FEDERAL ENERGY REGULATORY COMMISSION

**Atlantic Coast Pipeline, LLC
Dominion Transmission, Inc.**

**Docket Nos. CP15-554-000
CP15-554-001
CP15-555-000**

**COMMENTS OF
SHENANDOAH VALLEY NETWORK,
HIGHLANDERS FOR RESPONSIBLE DEVELOPMENT,
VIRGINIA WILDERNESS COMMITTEE,
SHENANDOAH VALLEY BATTLEFIELDS FOUNDATION,
NATURAL RESOURCES DEFENSE COUNCIL,
CONCERNED CITIZENS OF TILLERY,
COWPASTURE RIVER PRESERVATION ASSOCIATION,
DEFENDERS OF WILDLIFE,
DOMINION PIPELINE MONITORING COALITION,
FRIENDS OF BUCKINGHAM,
JACKSON RIVER PRESERVATION ASSOCIATION,
JAMES RIVER ASSOCIATION
NATIONAL PARKS CONSERVATION ASSOCIATION,
PIEDMONT ENVIRONMENTAL COUNCIL,
POTOMAC RIVERKEEPER NETWORK,
ROCKBRIDGE AREA CONSERVATION COUNCIL,
SHENANDOAH RIVERKEEPER,
SOUND RIVERS,
WATERKEEPERS CHESAPEAKE,
THE WILDERNESS SOCIETY, AND
WINYAH RIVERS FOUNDATION
ON THE
DRAFT ENVIRONMENTAL IMPACT STATEMENT FOR THE
PROPOSED ATLANTIC COAST PIPELINE AND SUPPLY HEADER
PROJECT**

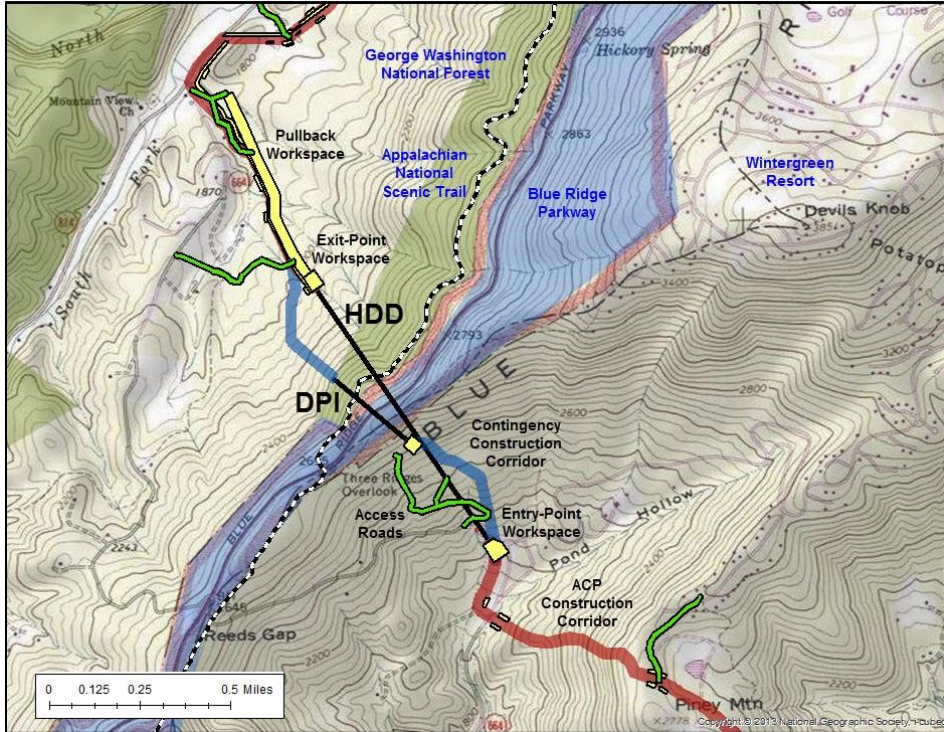
The HDD operation would involve drilling for 4,639 feet at 800 feet below the crest of the Blue Ridge.⁴⁸⁶ The contingency DPI operation would involve drilling for 1,396 feet at 200 feet below the crest.⁴⁸⁷ Both methods are commonly used for installing pipelines under rivers or other obstacles where the terrain is relatively flat and extremely hard or fractured bedrock is not encountered. The use of either method to drill for long distances through steep mountains is less common. Atlantic’s proposal for drilling through the Blue Ridge approaches the limits of

FIGURE VII(e) – Extreme pullback required for the proposed Blue Ridge HDD.

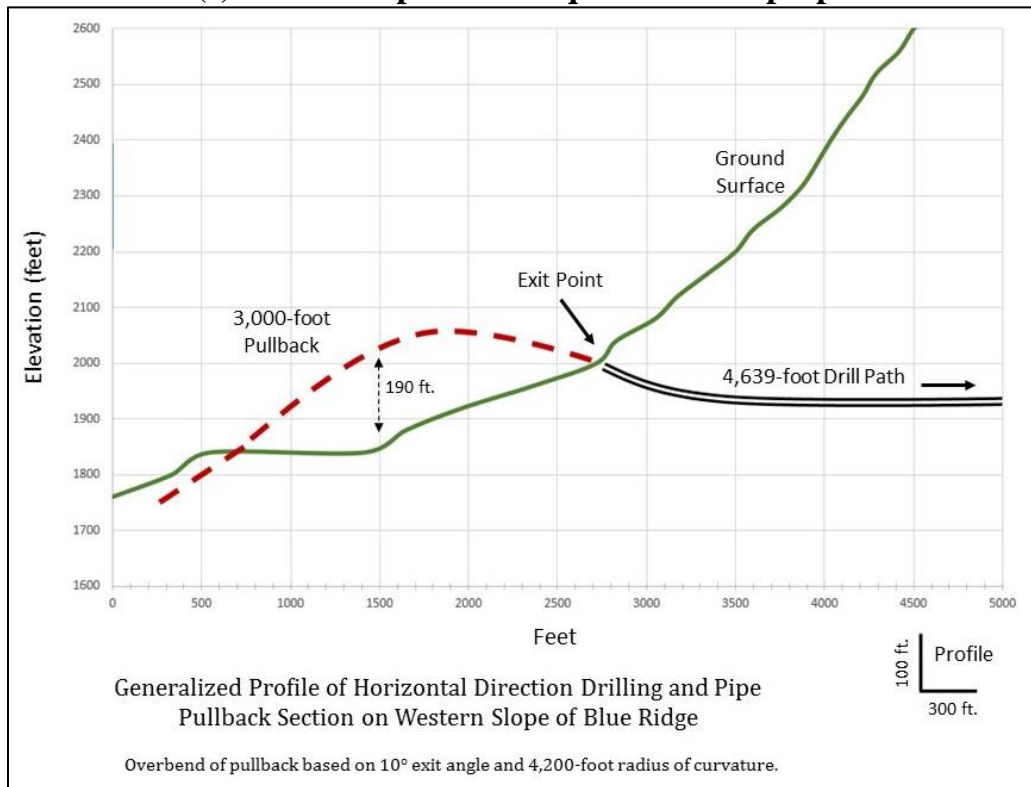
inch steel pipe is 4,200 feet.⁴⁹⁷ Given this bending radius and the slope of the location, it will be necessary to suspend the pipe for approximately 2,000 feet at heights approaching 200 feet above the mountainside (see **Figure VII(e)**). If this is even practicable, it will require significant excavation for access, pipe fabrication and testing, and siting of the multiple large cranes or other heavy equipment needed for pipe handling and support. The required suspension of pull-section pipe for the proposed mountainside HDD operation greatly exceeds what is required for typical HDD operations on relatively flat ground. For example, see **Figure VII(f)**.

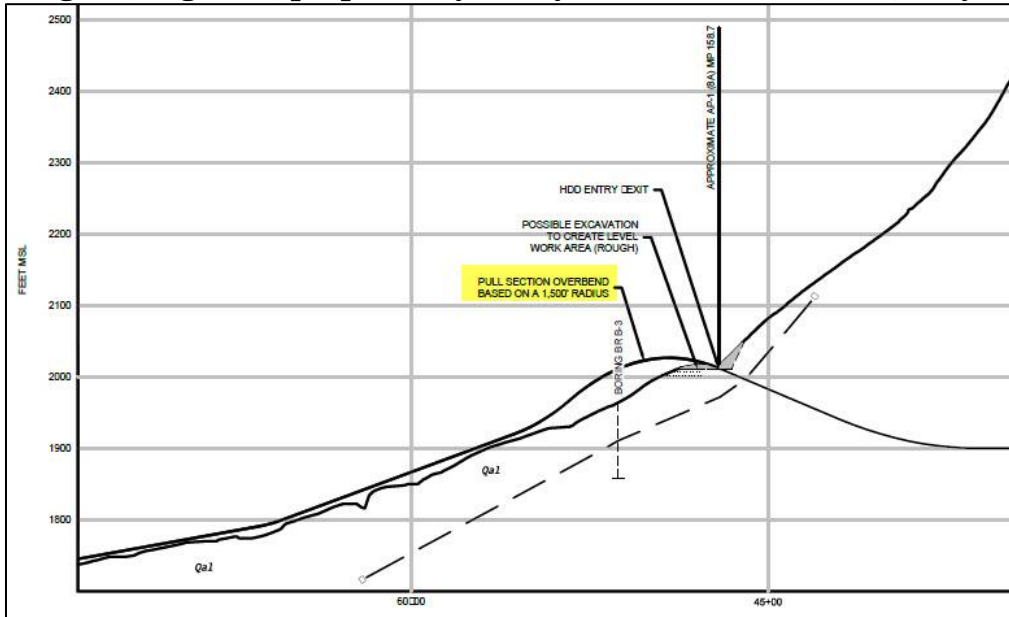
The contingency DPI installation, which would occur on even steeper slopes than the proposed HDD operation, also raises questions about the potential footprint of the staging and fabrication area and the need for pipe suspension.⁴⁹⁸ The fact that the suspension of pullback pipe and the magnitude of the related footprint were not addressed in the draft EIS may be due to incorrect or misleading information provided to the Commission by Atlantic. The only depiction of the HDD pullback section included in Atlantic submissions to the Commission is based on a 1,500-foot bending radius (see **Figure VII(g)**).

This differs substantially from the correct 4,200-foot bending radius. As indicated in the depiction, a shorter bending radius would require much less lifting of the pipe. The necessary elevation would only be about 50 feet compared to about 200 feet for the longer correct bending radius. The length of pipe suspension would also be much less.

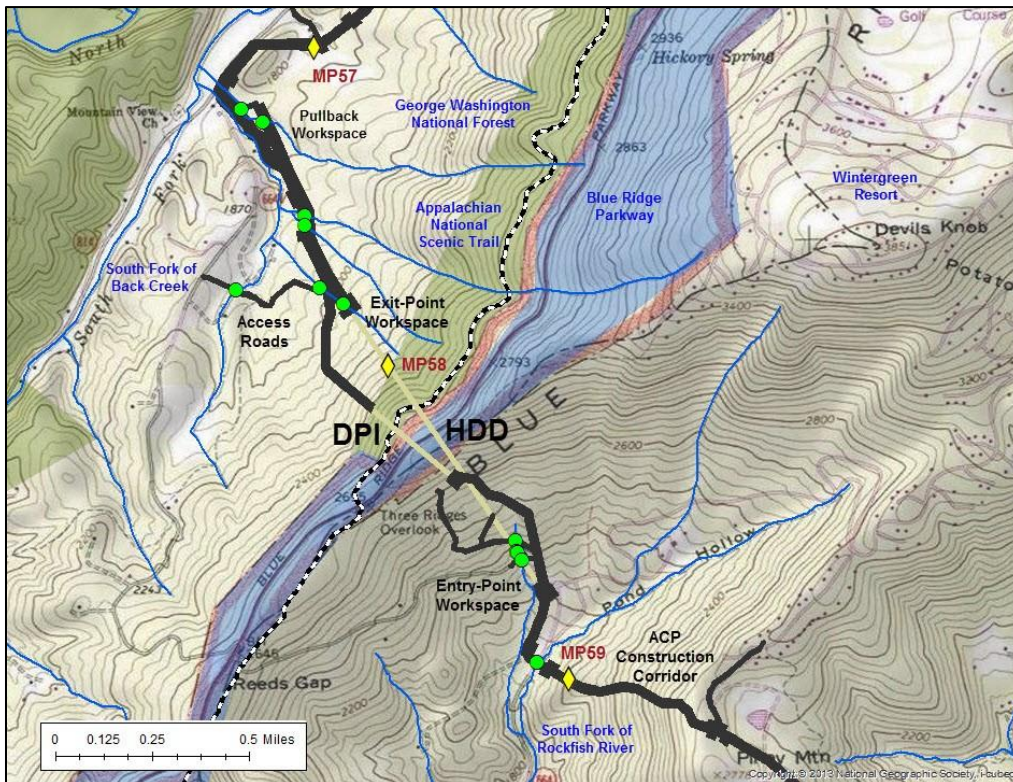
TABLE VII(a) – Water Crossing Information: Excerpt from draft EIS⁵⁰¹

FIGURE VII(i) – Recommended exit-side and pullback pipe fabrication workspace.

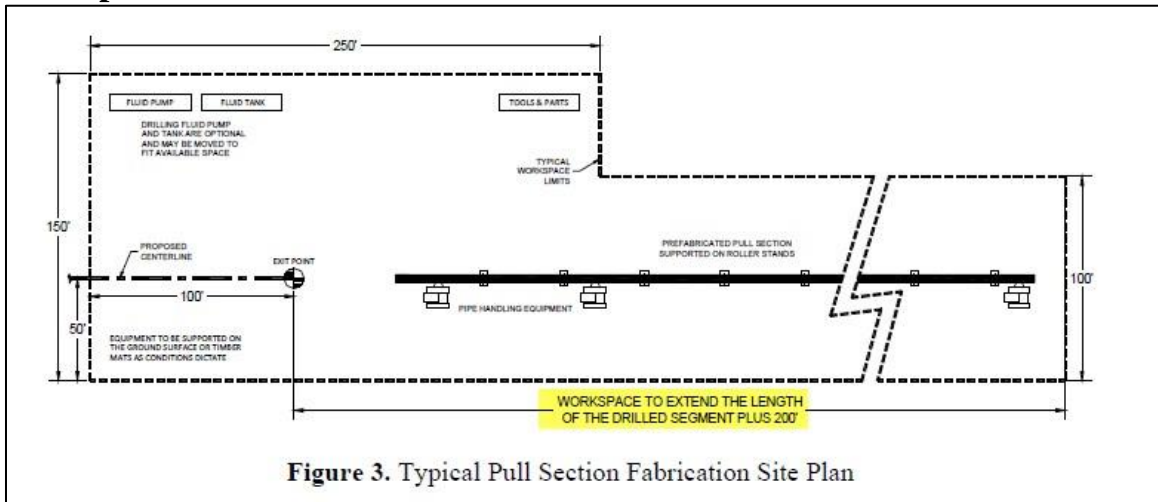
The length of the drilled segment for Atlantic’s proposed HDD is 4,639 feet. The recommended pullback segment would thus be 4,839 feet. However, as indicated in the draft EIS, the length of the workspace available for staging the pipe pullback is only about 3,000 feet, which makes fabrication, hydrostatic testing, and pullback of the recommended single continuous pipe string impossible.

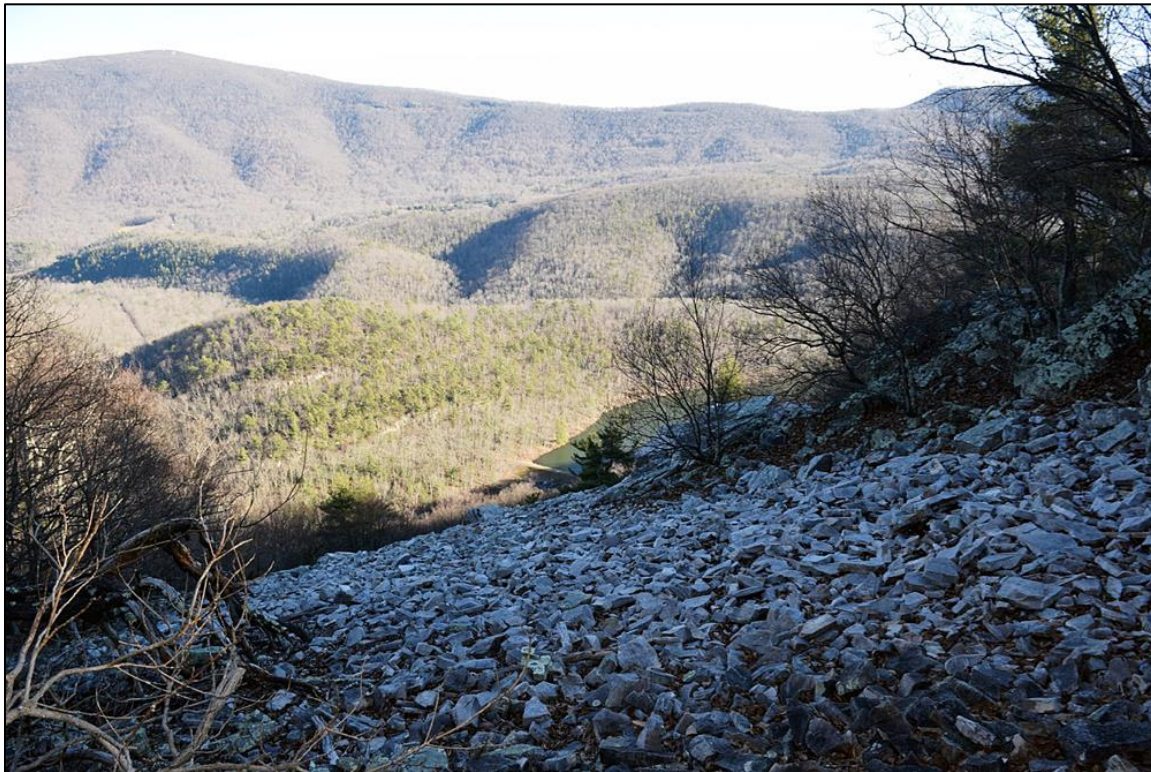
Figure VII(j) shows the exit-side and pullback area for the proposed HDD on western slope of the Blue Ridge.

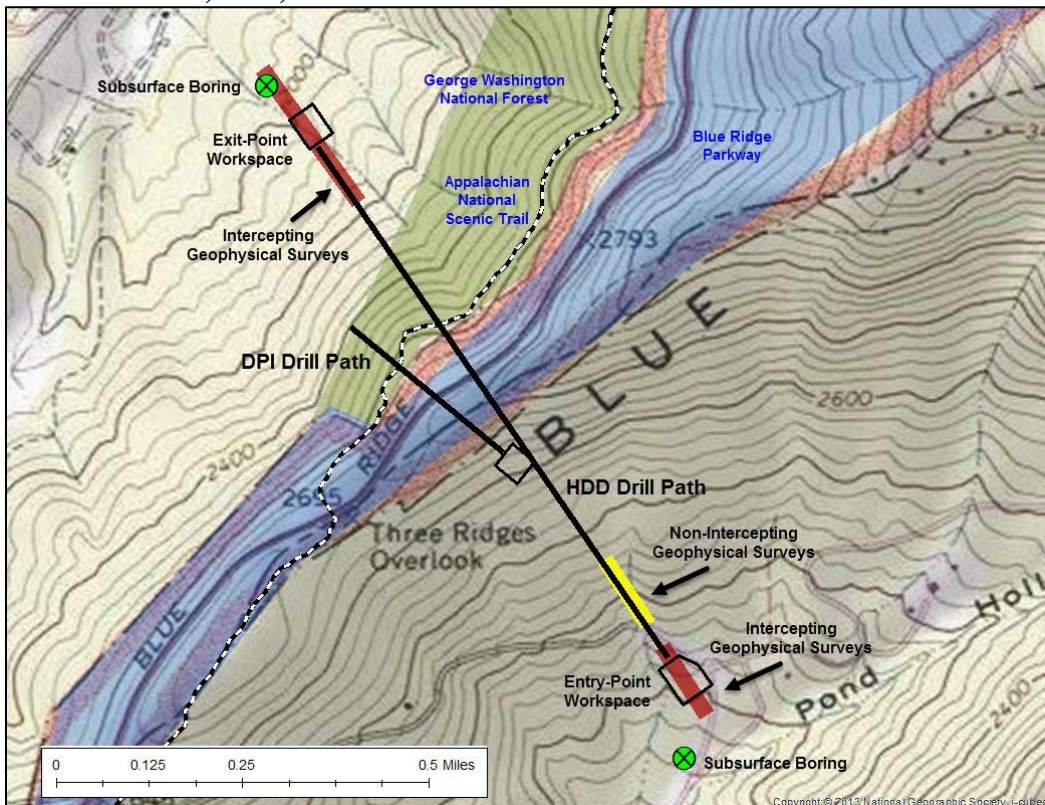
the two subsurface borings and other geophysical surveys for the HDD are indicated in **Figure VII(k)**.

Neither the borings nor the geophysical surveys were focused on the full length of the proposed drill path, and none of the information obtained through borings or geophysical surveys confirms “that the drill path would be primarily through solid

FIGURE VII(1) – Interpreted results of geophysical surveys conducted at the entry- and exit-sides of the proposed HDD drill path. (Based on Geophysical Study for a Proposed Blue Ridge HDD Crossing Augusta and Nelson Counties, Virginia, prepared by ATS International, Inc., 4/12/16.)

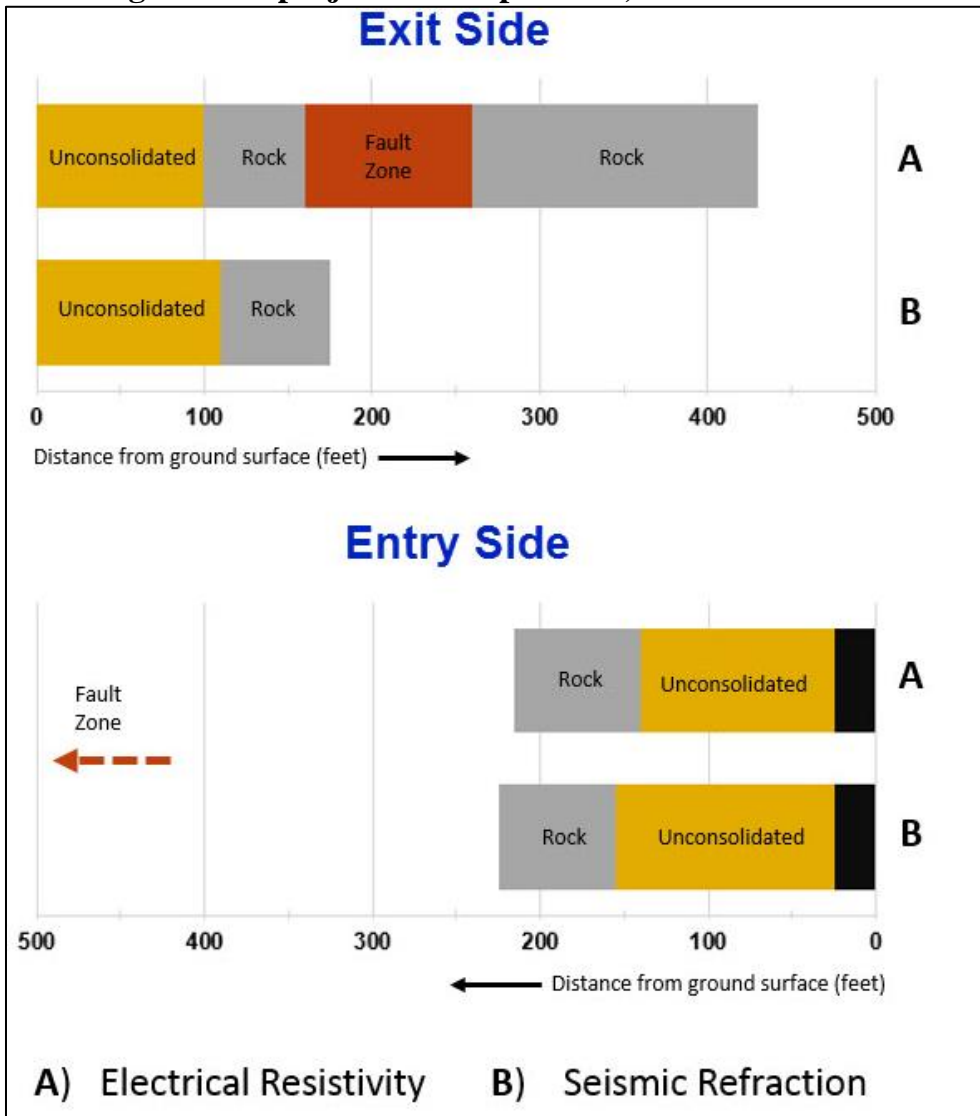
Results are shown for survey sections where imaging intercepted the projected drilling path. The fault zone in the entry-side section was estimated based on non-intercepting surveys, and was estimated to begin at 425-550 feet from the ground surface. The black-colored segments starting at the ground surface on the entry side indicate planned excavation. The total length of the projected drill path is 4,639 feet.

In fact, the geophysical services company that conducted and interpreted the surveys raised questions concerning the reliability of even its limited findings,
